THE HOTEL AT FOUNDRY PLACE, "LOT 3": 165 DEER STREET, ASSESSORS MAP 125 LOT 17, AND RELATED IMPROVEMENTS TO LOTS 2, 4 AND 5

SITE PLAN REVIEW

COVER SHEET

EASEMENT TO EVERSOURCE AND TELECOMM

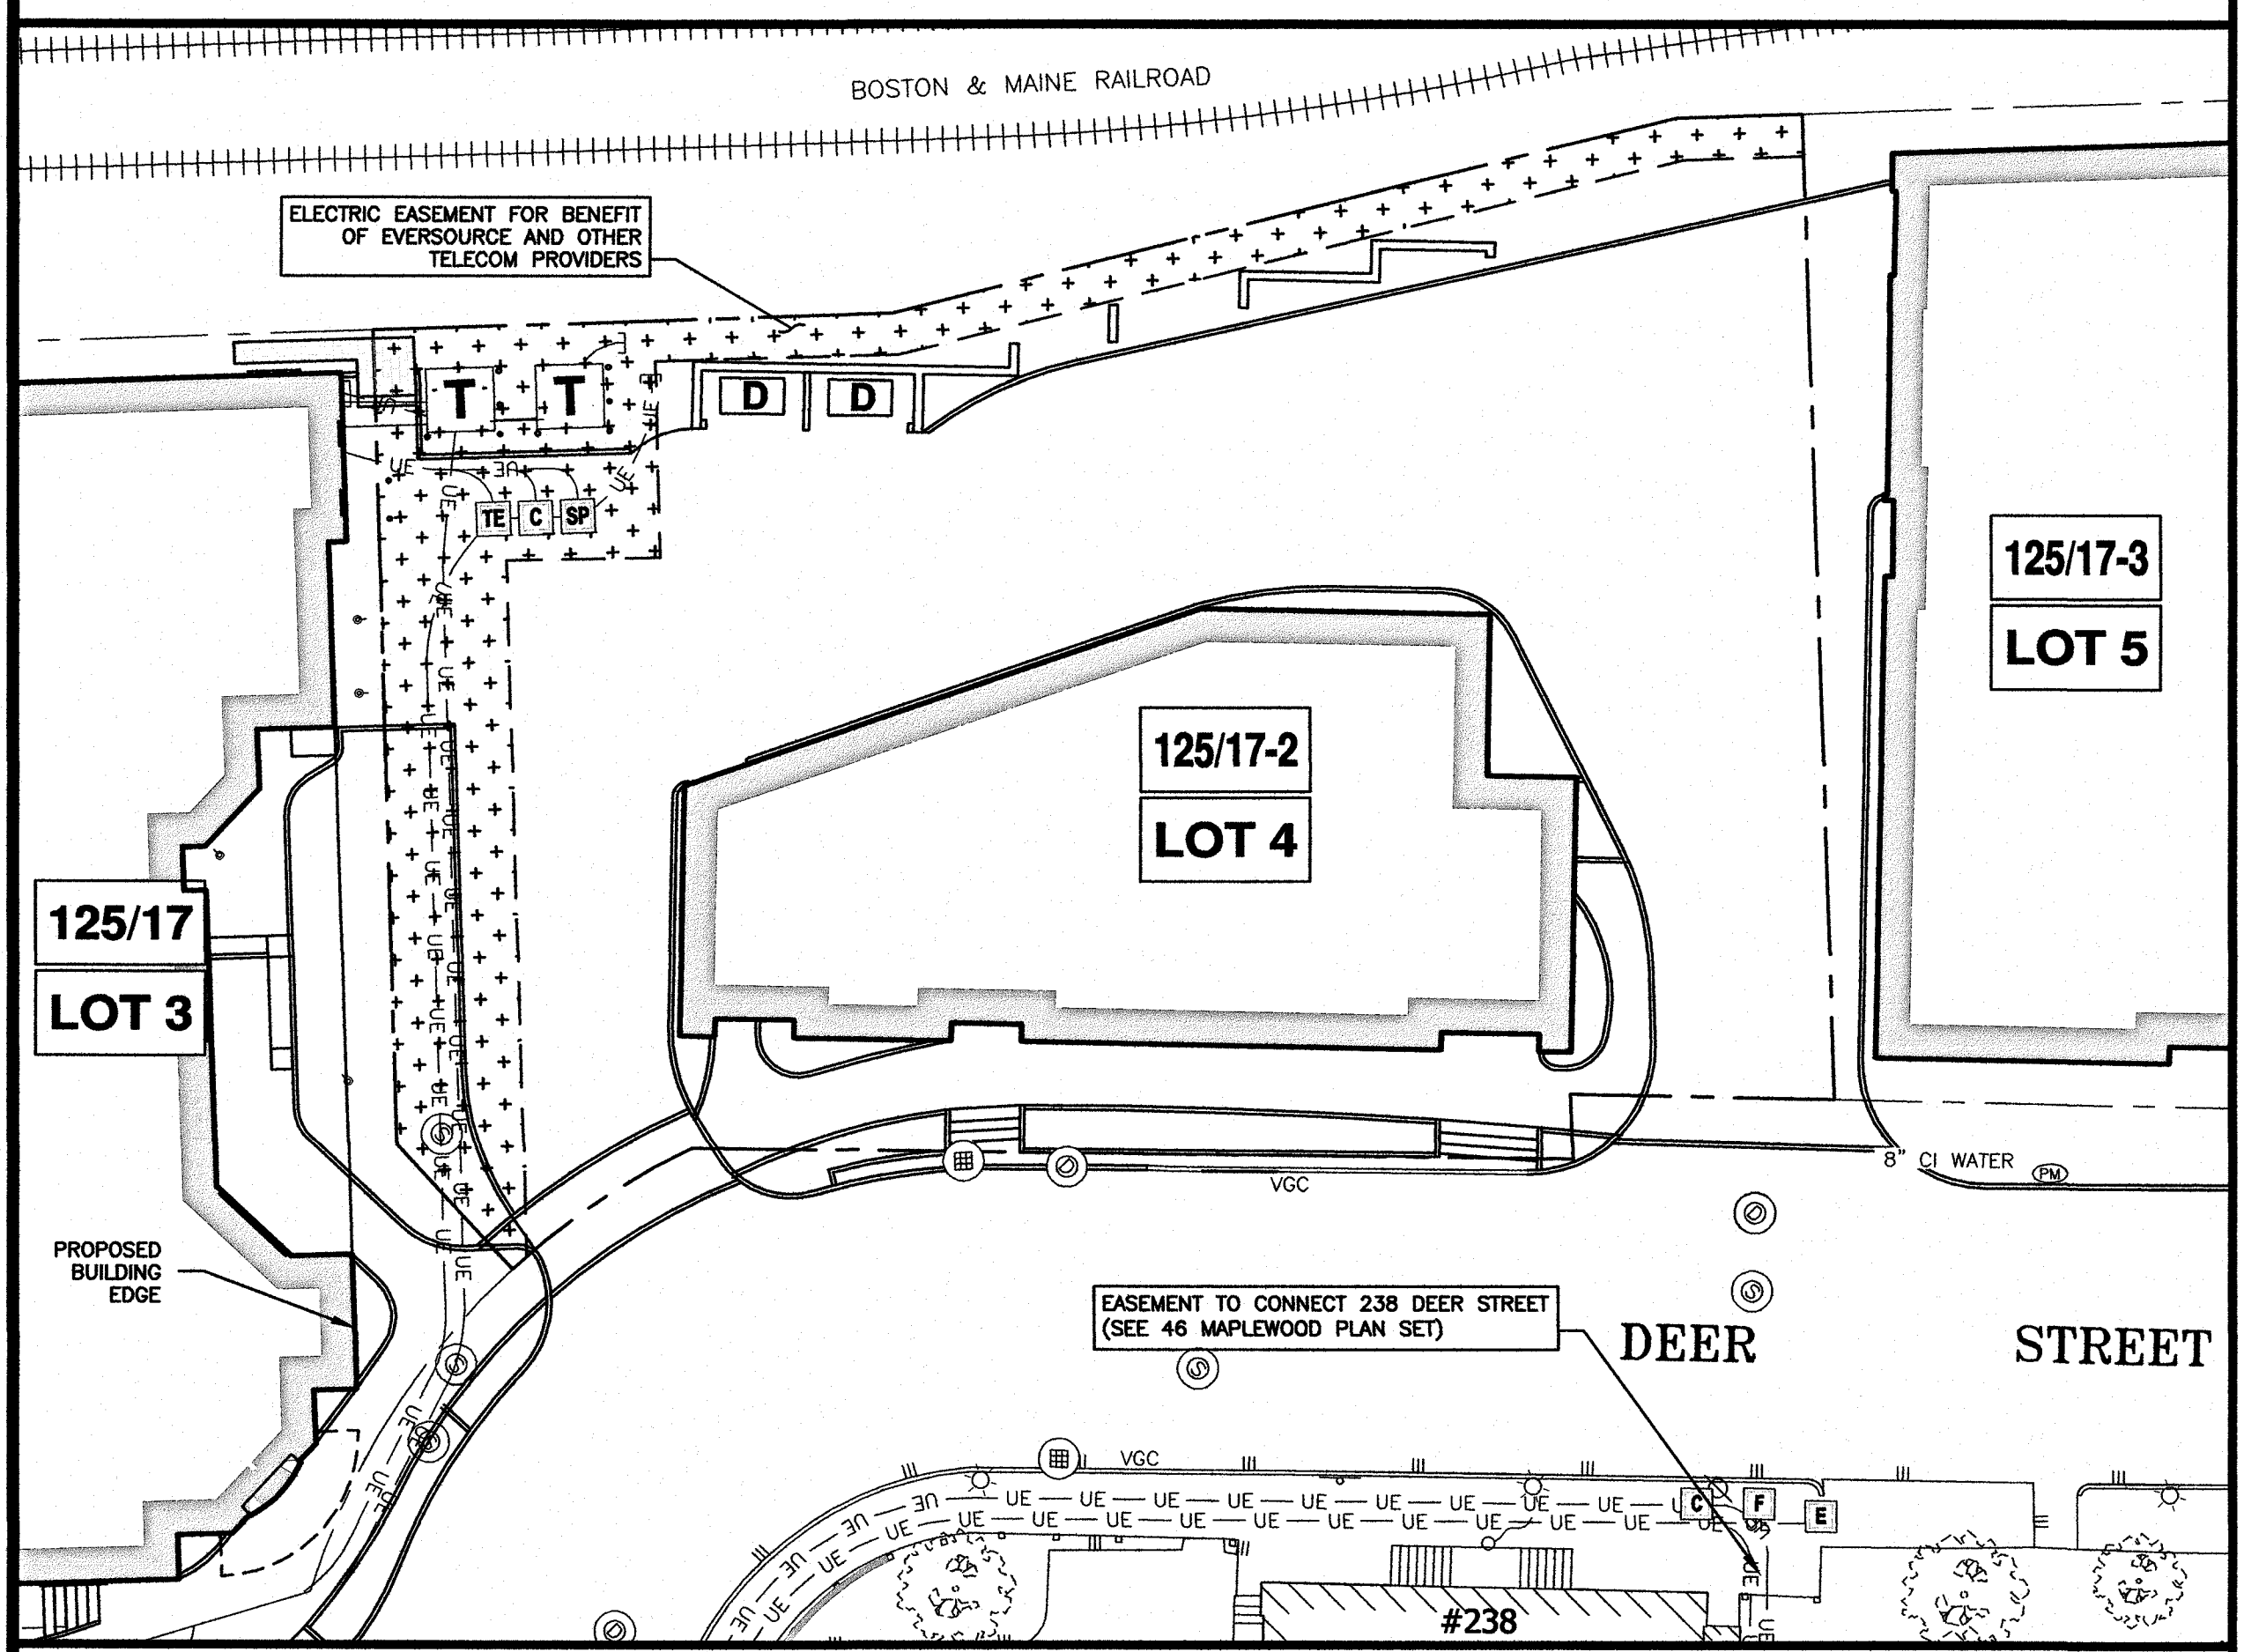
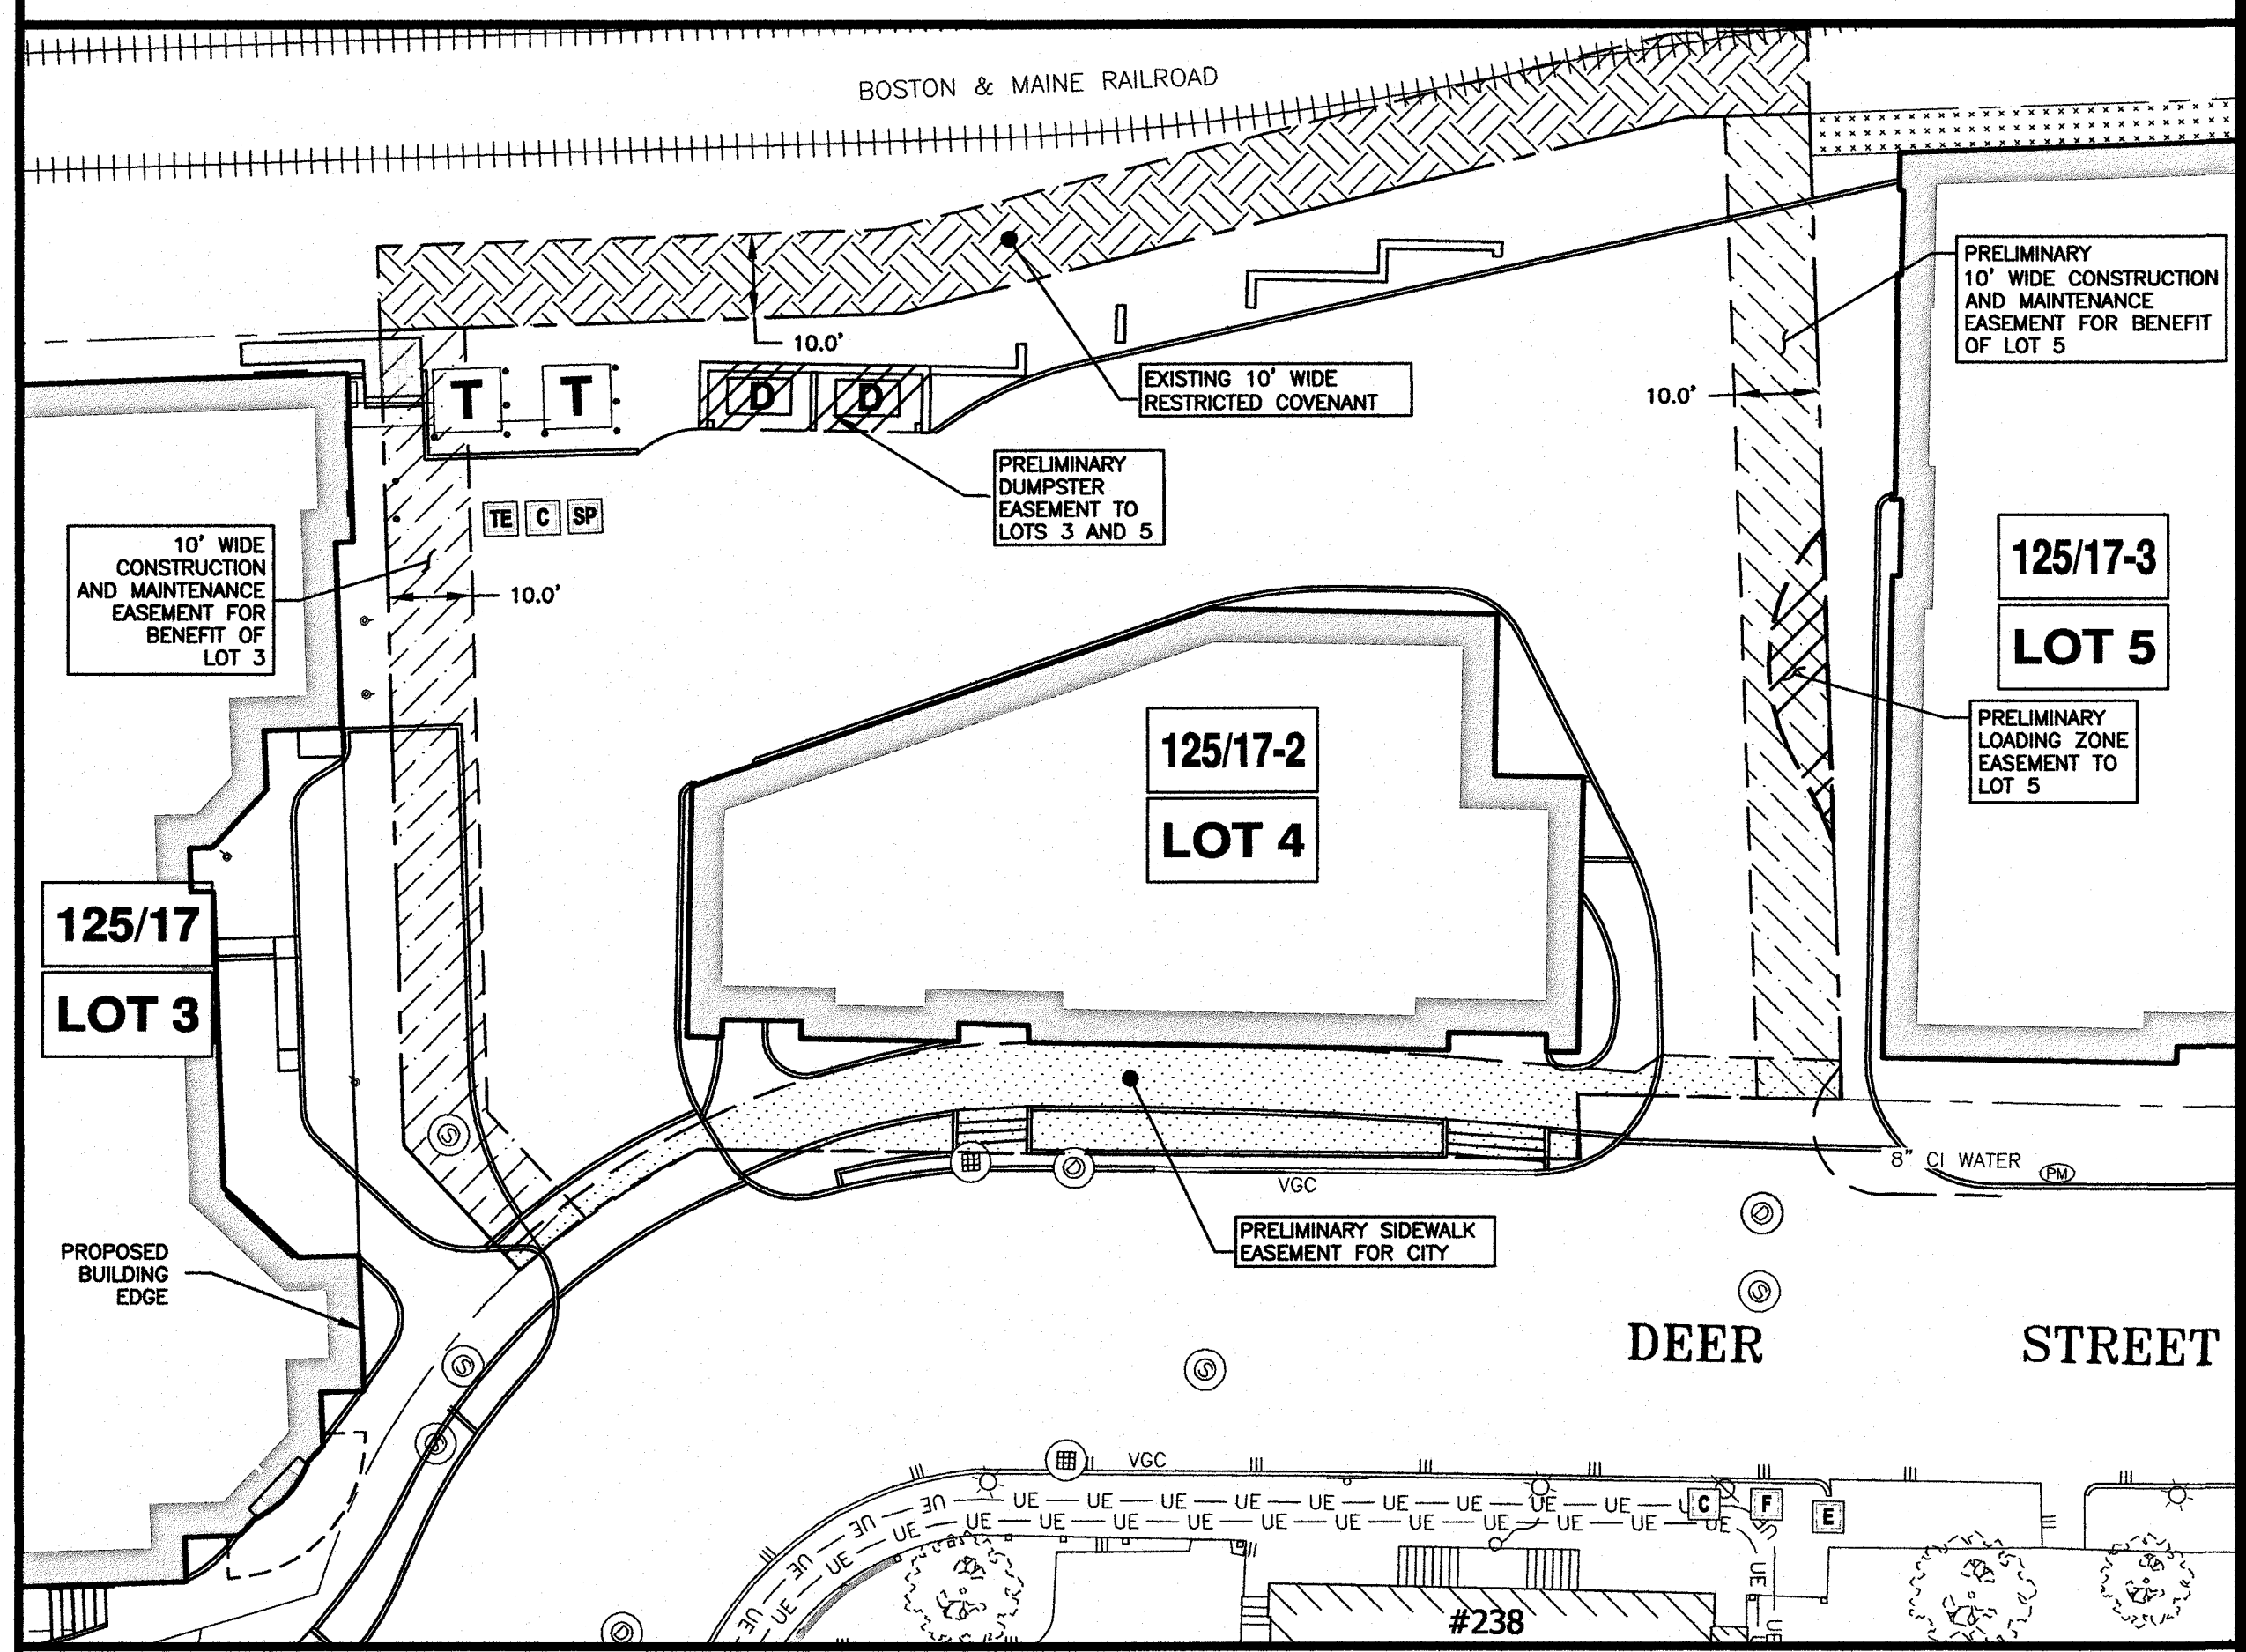
22	Update the Easement Table and Easement Figures to match; make sure it includes the electric easement on Lot 4 for Lot 3.	Resolved	Sheets E1, E2, and E3, and the Easement Summary Tables included in Attachment B were edited to be consistent and are included in the submittal.
23	City wants to control the ability to light the sidewalk, therefore they want decorative City street lights installed. Resolve light provided/guaranteed by building with City lights.	Addressed	Sidewalk lights are shown on Sheet L2. Updated building lighting information is included in Attachment G.
24	Update the zoning compliance table to include required dimensional information. Update square footage.	Addressed	Zoning compliance table updated. Dates of approvals for variances sought also included (Sheet T.02T).
25	Revisit Community Space calculation if outside tables are going to be used on sidewalks.	Addressed	Community Space calculations and illustrations (Sheet C3.3) was revised to exclude terrace area in front of hotel and is included.
